**ADDENDUM NUMBER ONE**

**CHARLES A. BELL PARK**

**ENGINEER:** BARGE, WAGGONER, SUMNER & CANNON, INC.  
1110 Market Street  
Chattanooga, Tennessee 37402

**ADD. NO. 1 ISSUED DATE:** October 14, 2016

L7.02

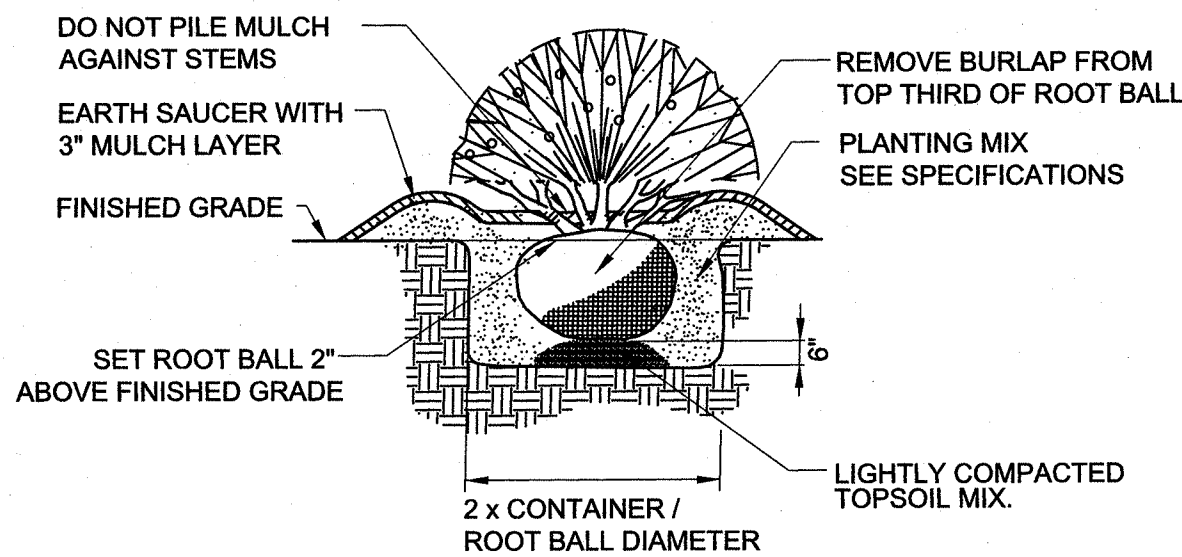
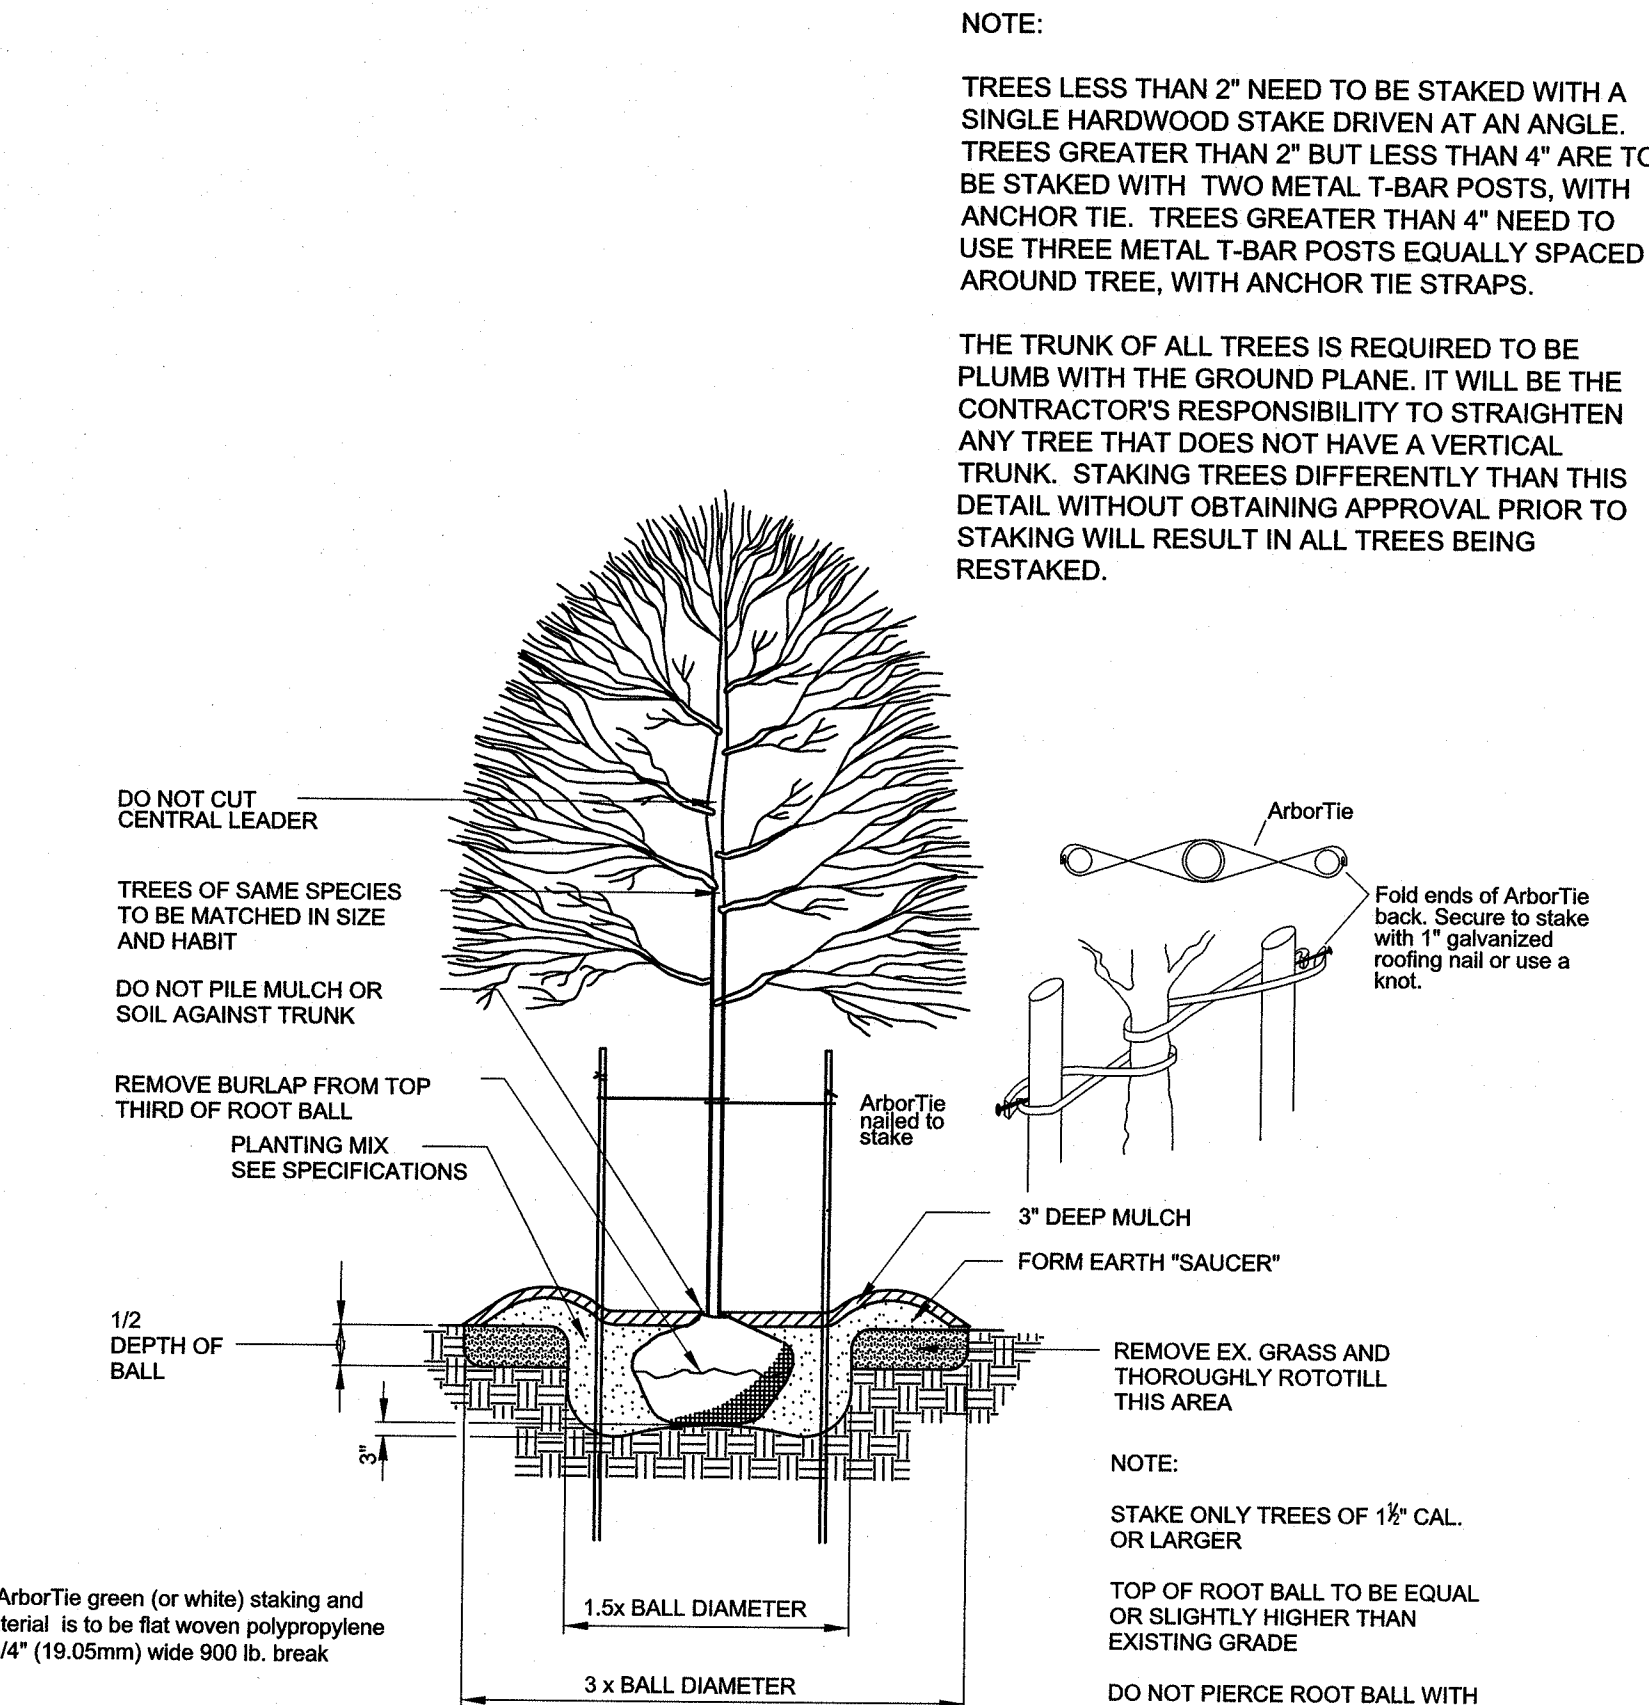
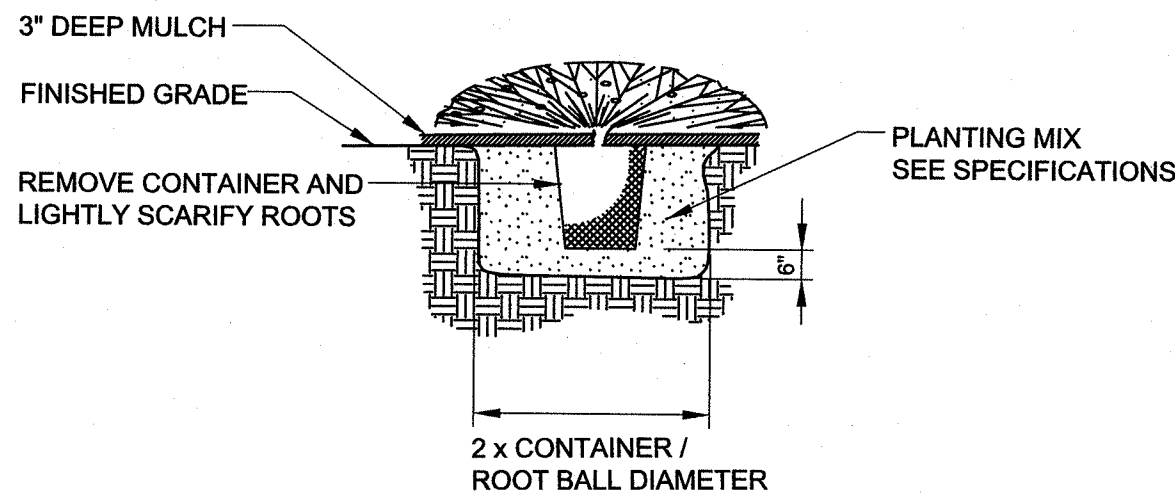
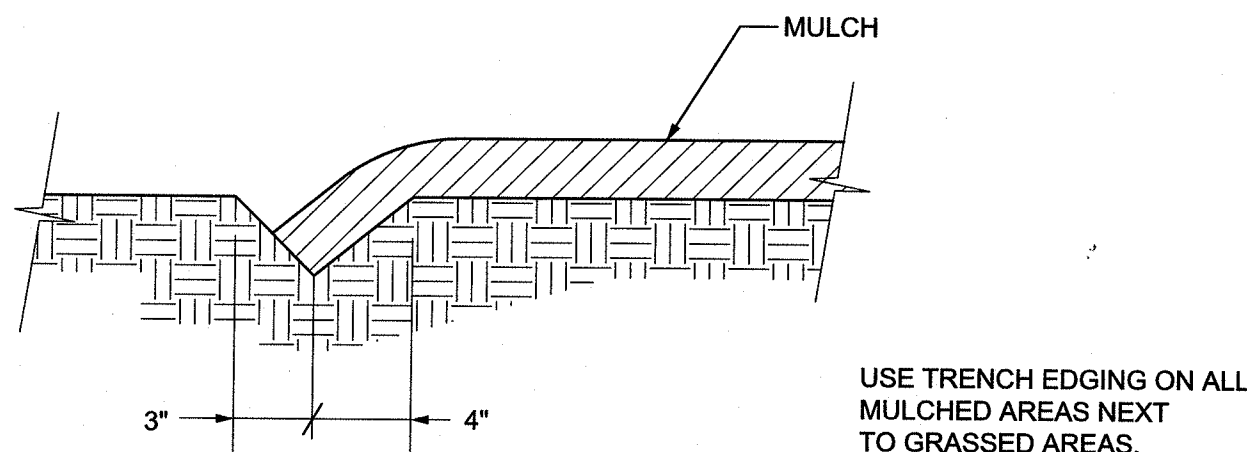
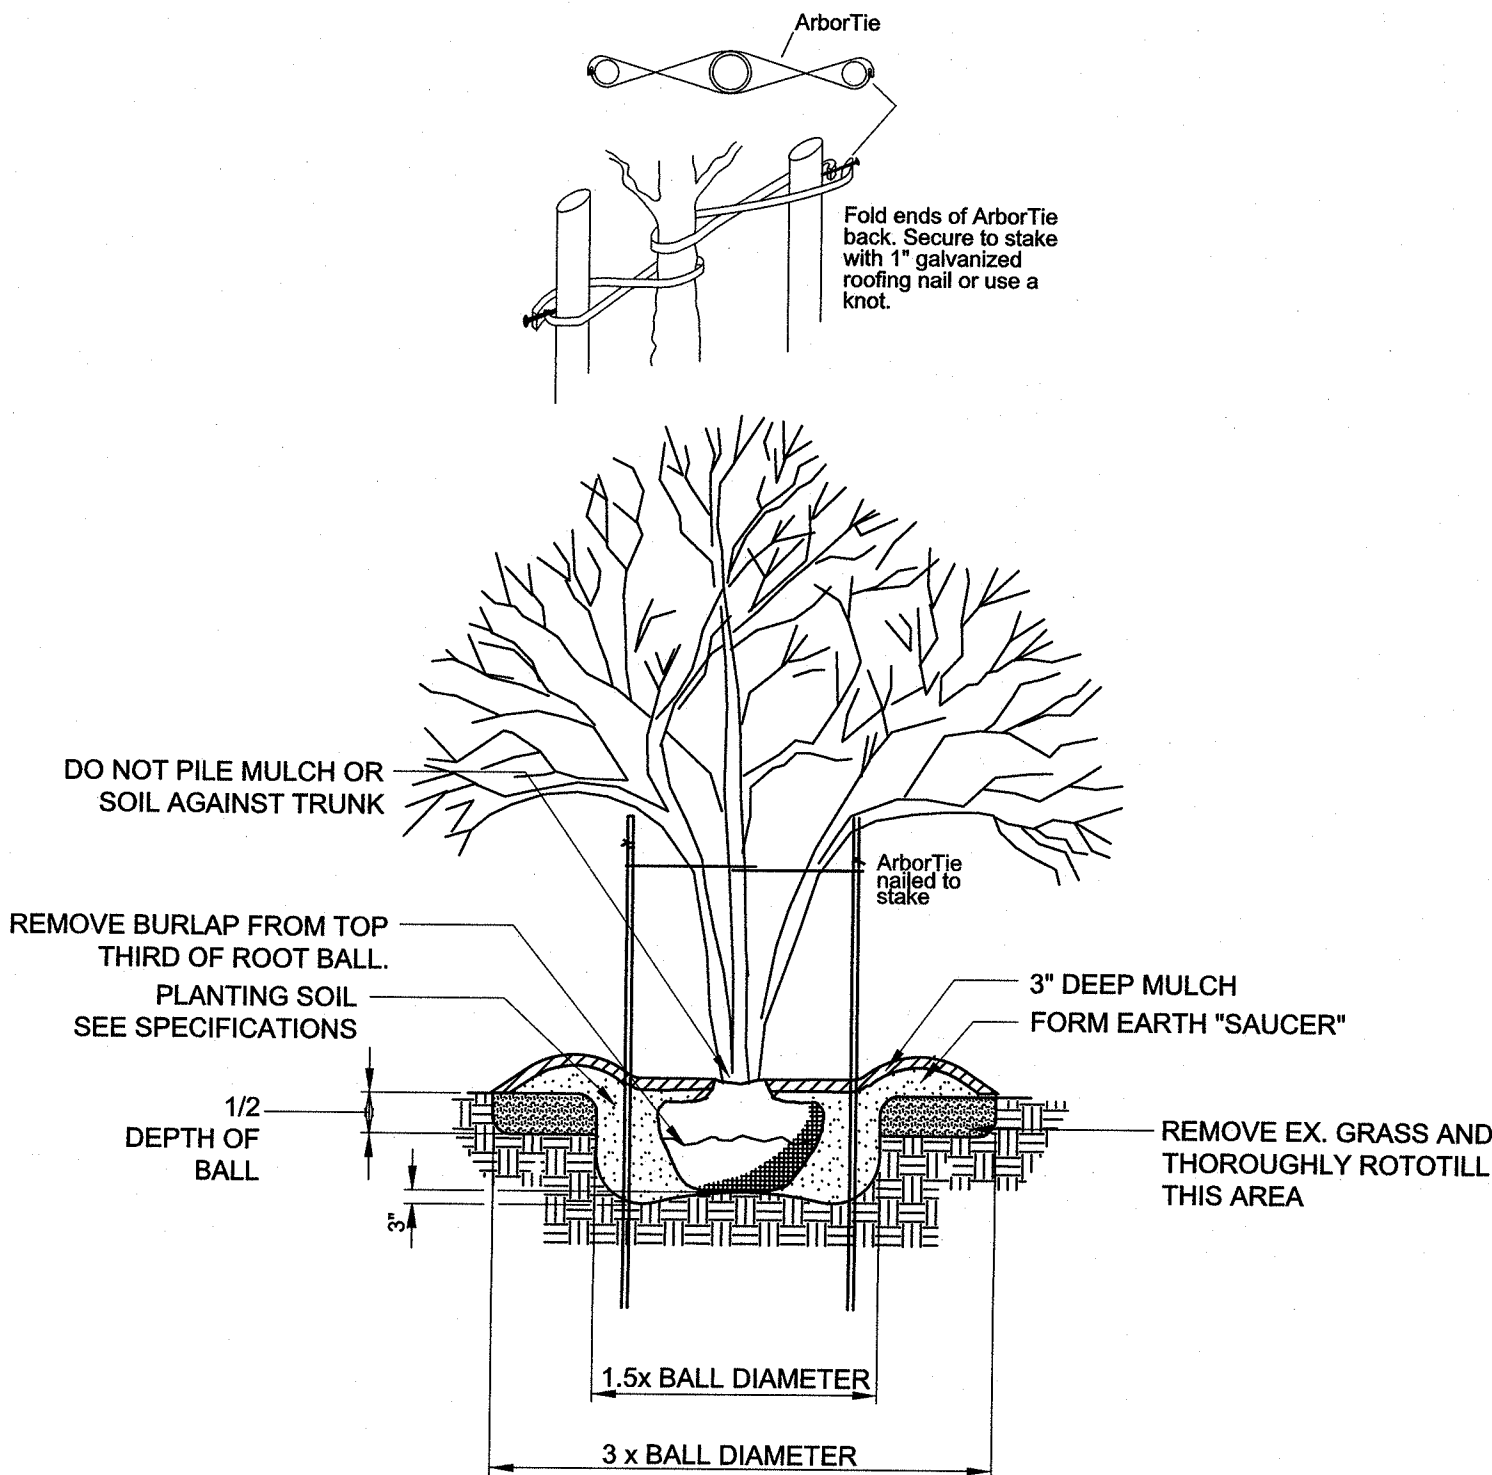
ITEM C4: Sheet L7.02: Revised plant schedule quantities and added seed quantities.

REV.	DR.	CHK.	DATE	DESCRIPTION
0	BSP	TDG	09-26-2016	ISSUED FOR PERMITTING
1	BSP	TDG	10-14-2016	REVISED PLANTS

1  
E3-0  
SITE ELECTRICAL PLAN  
Scale: 1" = 20'-0"

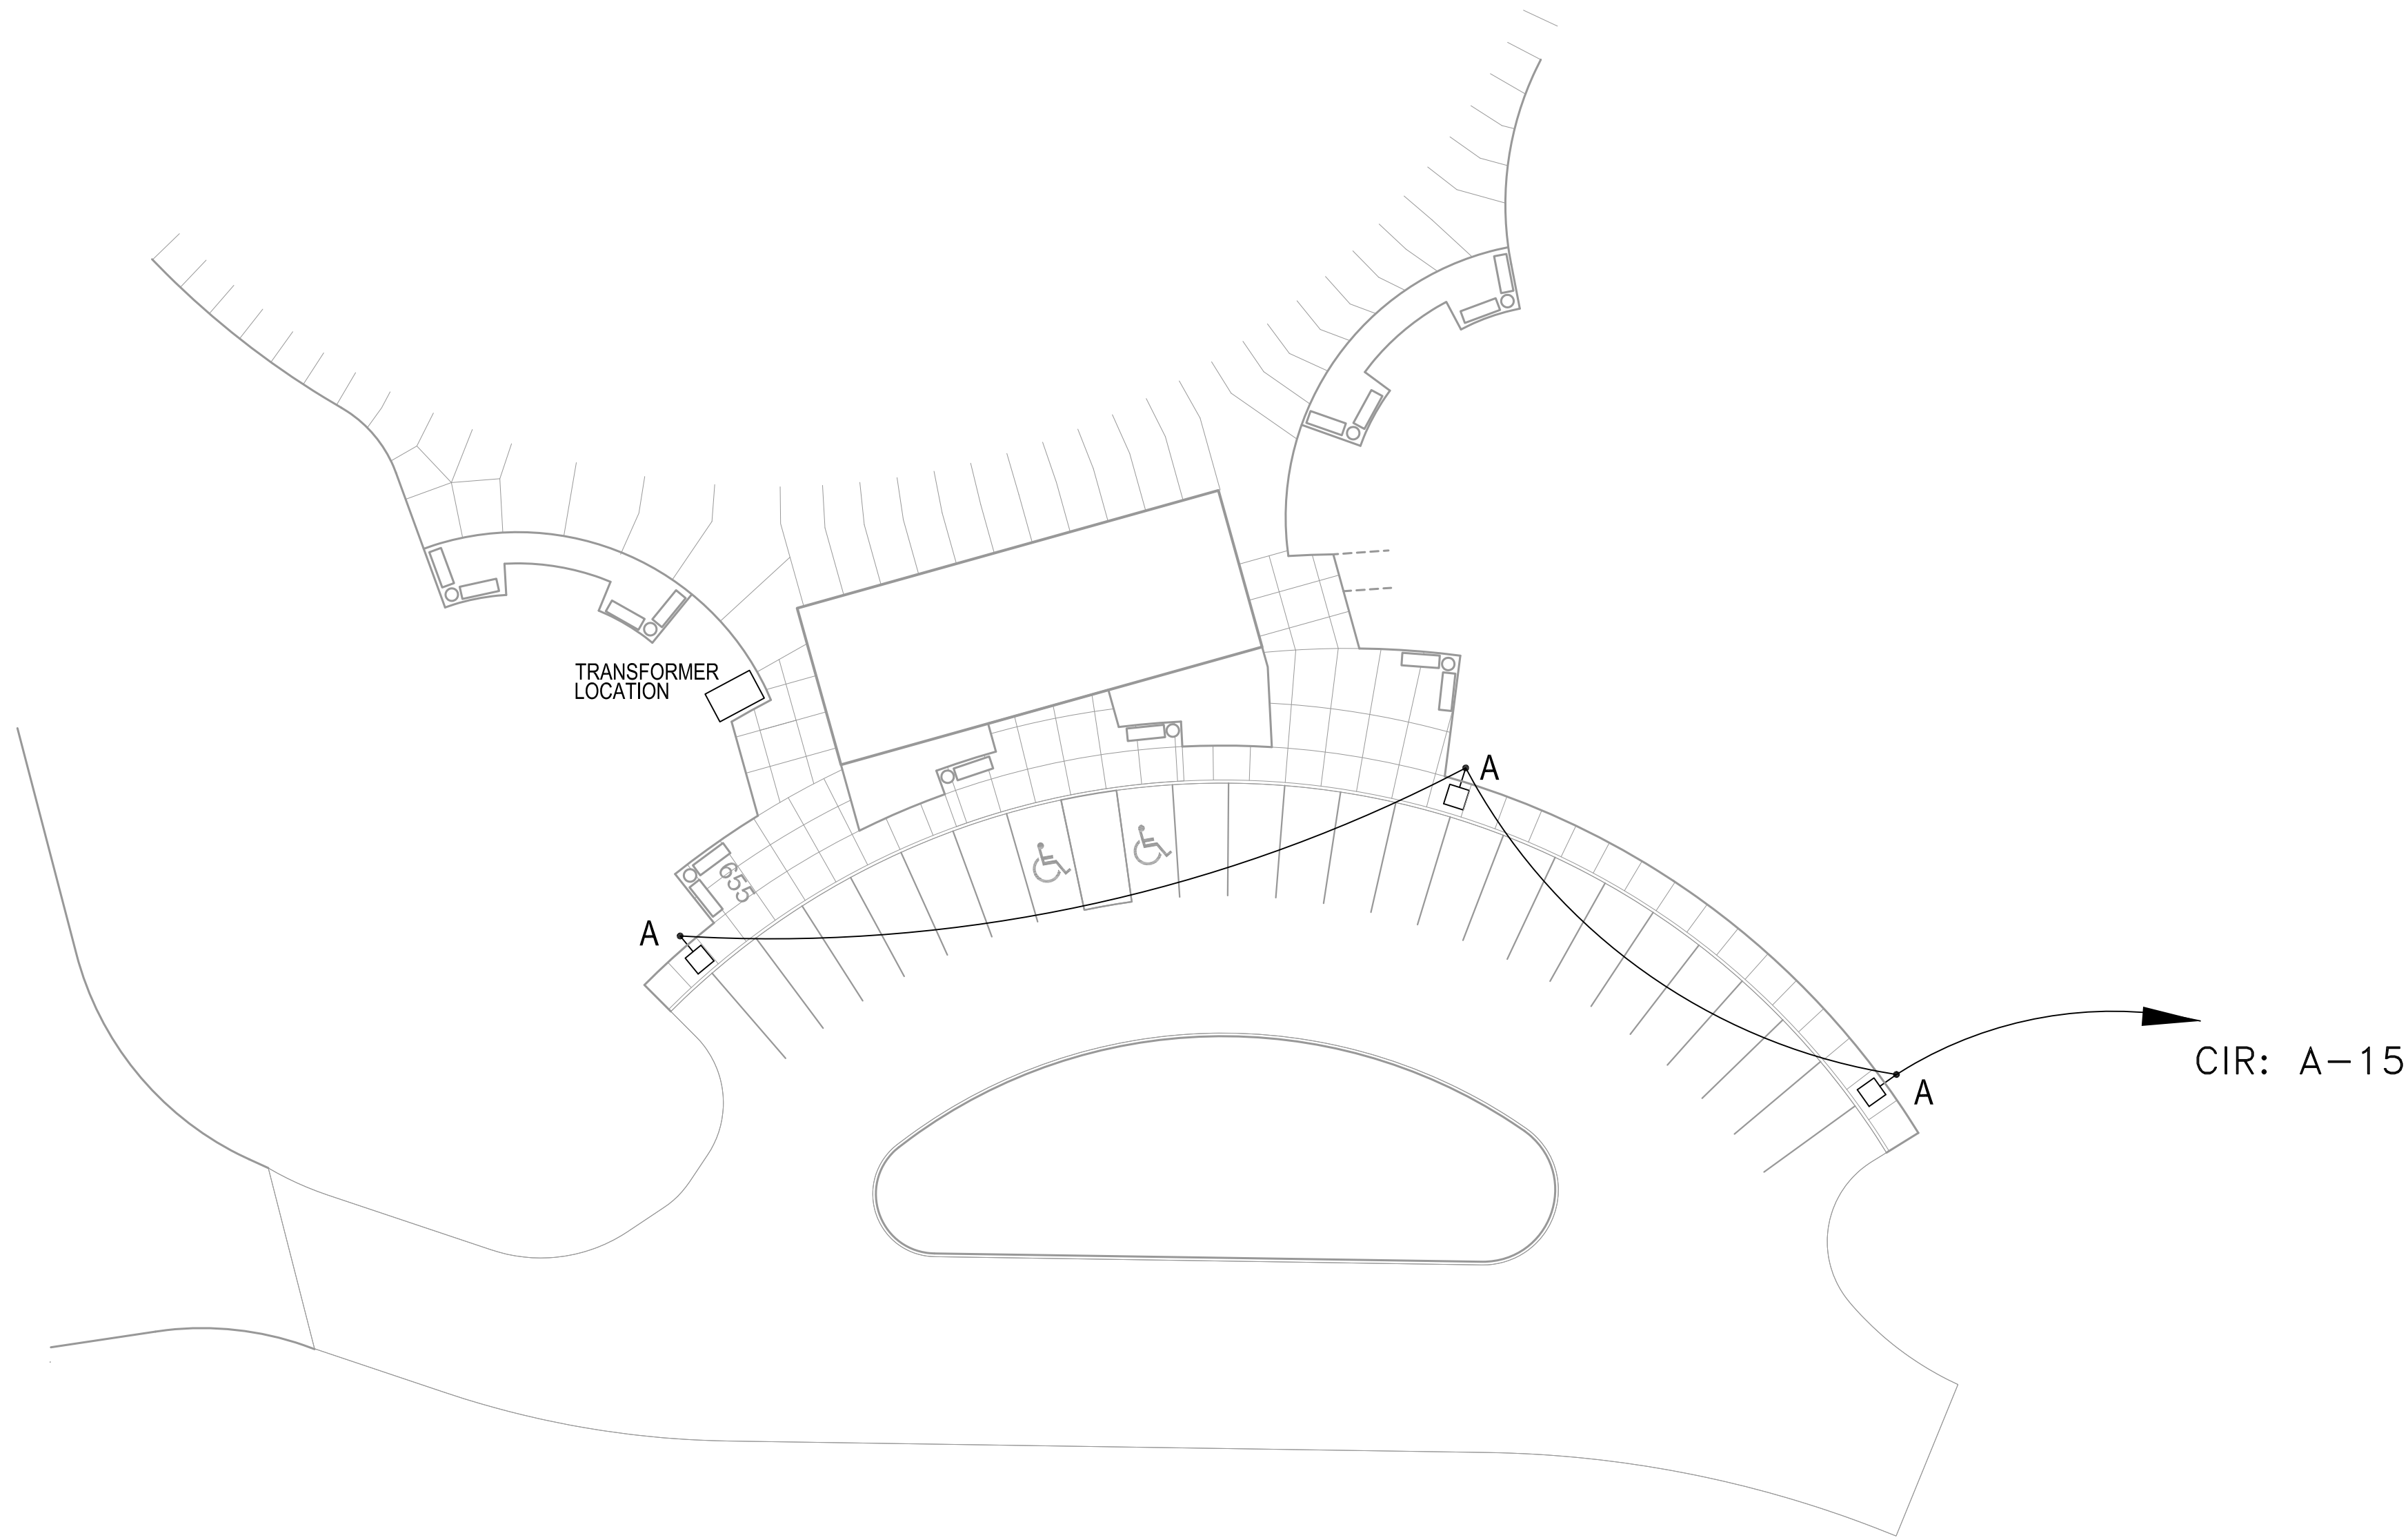
ITEM C5: Sheet E3-0: Electrical Site Plan
